Office Action Summary	Application No. 10/767,404	Applicant(s) DOJAN ET AL.	
	Examiner Michael C. Miggins	Art Unit 1772

DETAILED ACTION

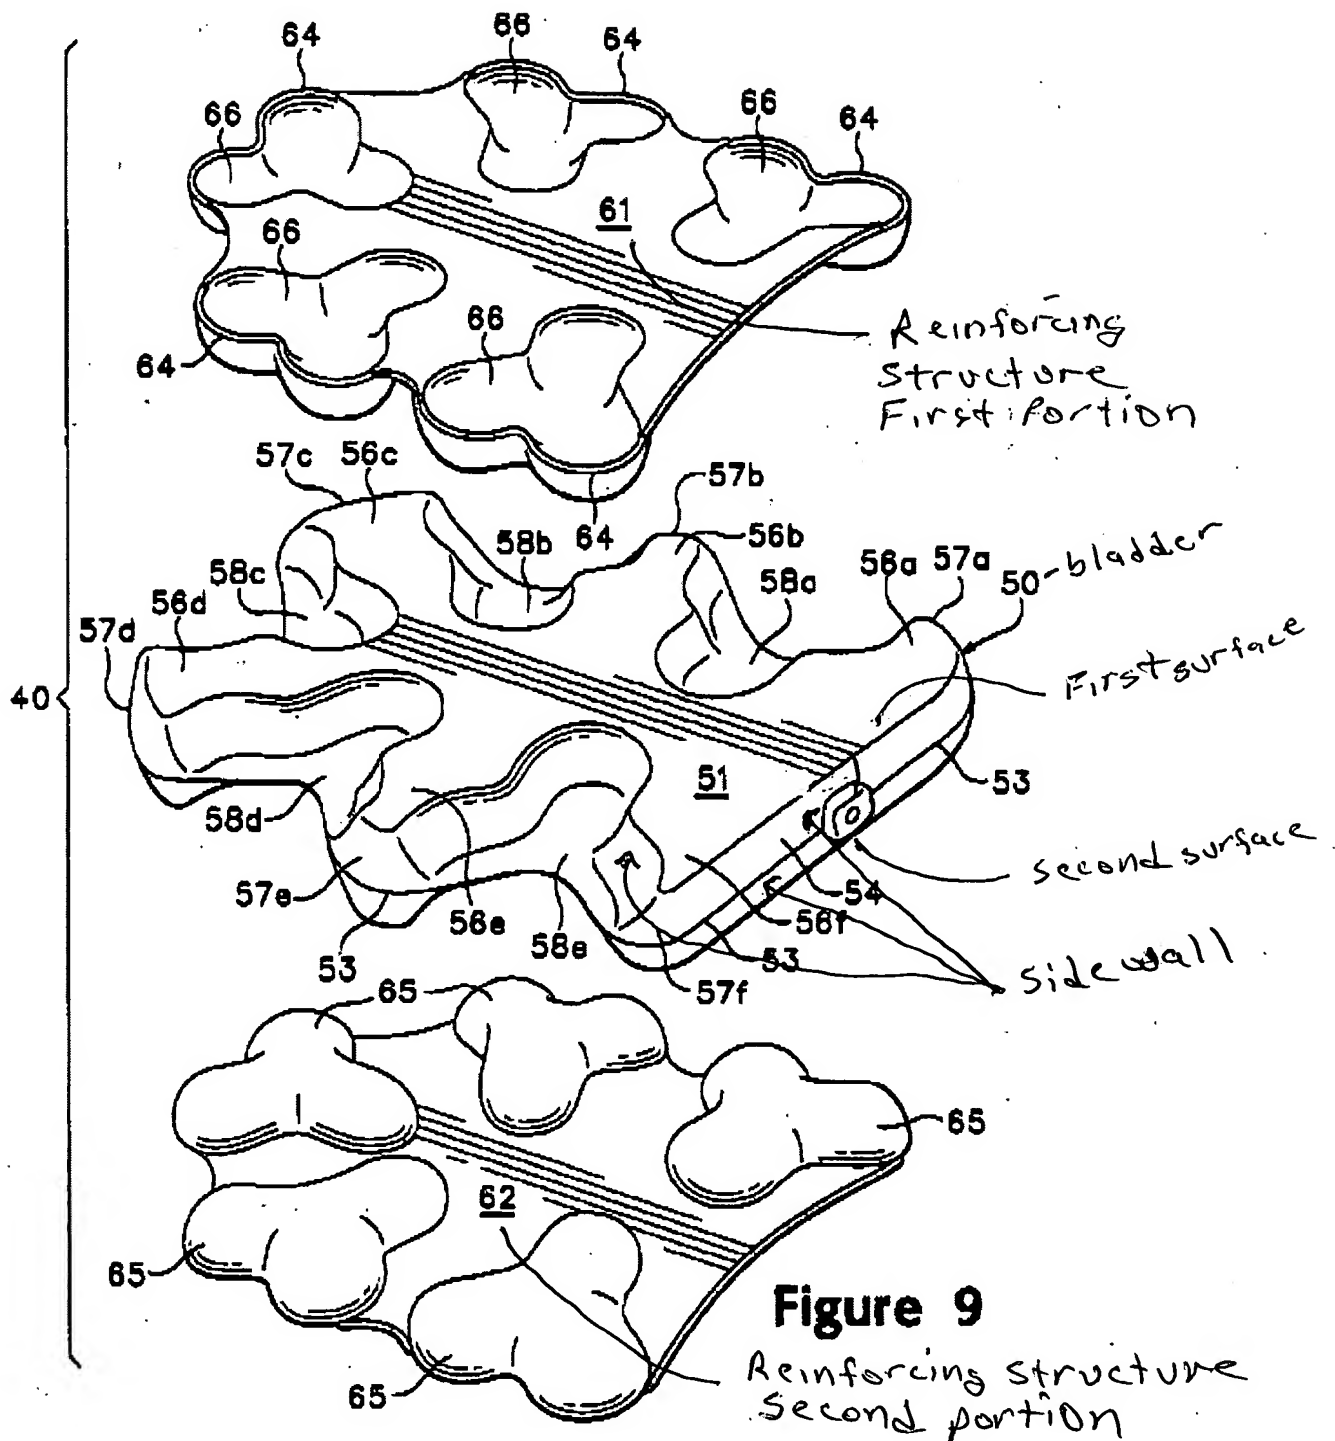
Swigart discloses a component comprising a bladder formed of a barrier material (since chamber 50 contains air, page 4, paragraph [0044]), the bladder enclosing a fluid that exerts an outward force upon the barrier material (since chamber 50 contains air, page 4, paragraph [0044]), and a reinforcing structure at least partially recessed into the barrier material and bonded to the barrier material (page 4, paragraph [0048]), at least a portion of the reinforcing structure being placed in tension by the outward force upon the barrier material (since a pressure greater than 5 psi may be placed in the bladder, page 4, paragraph [0044]) and wherein the reinforcing structure is formed of a semi-rigid material that is bonded to the bladder (page 4, paragraph [0048], page 5, paragraph [0053]) (see also Figs. 9 and 5 along with annotations below).

Swigart also discloses wherein the bladder includes a first surface, an opposite second surface and a sidewall extending between the first surface and the second surface (see Fig. 9 below).

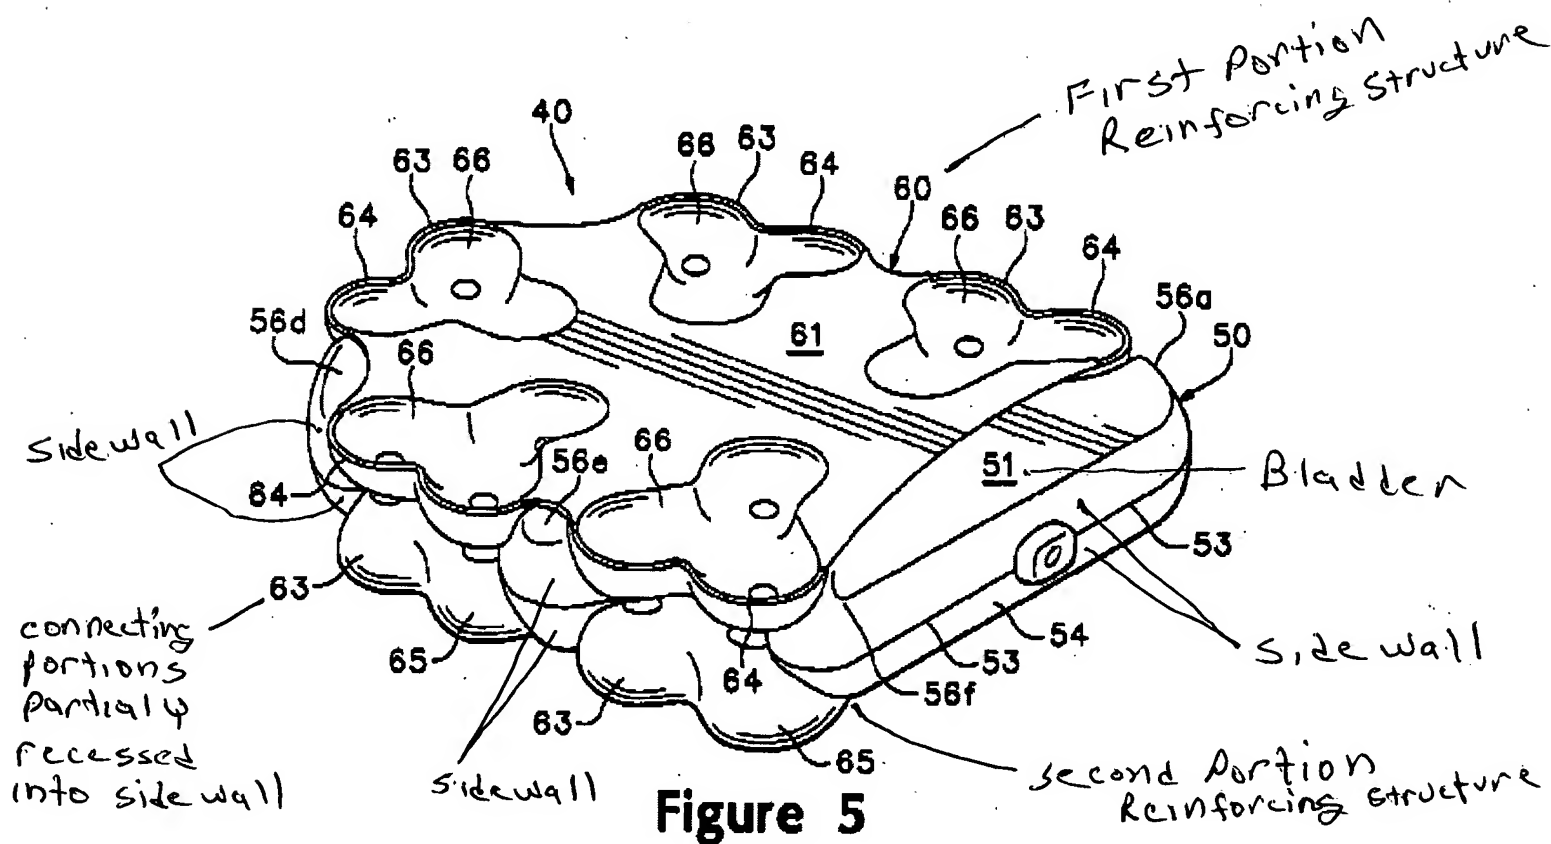
Swigart discloses wherein the reinforcing structure has a first portion, a second portion and a plurality of connecting protrusions (63) extending between the first portion

and the second portion and wherein the first portion is secured to the bladder at an interface between the first surface and the sidewall, and the second portion is secured to the bladder at an interface between the second surface (page 4, paragraph [0048], page 5, paragraph [0051]) and the sidewall and wherein the connecting portions are at least partially recessed into the sidewall (see Figs. 4, 6 and 5 below).
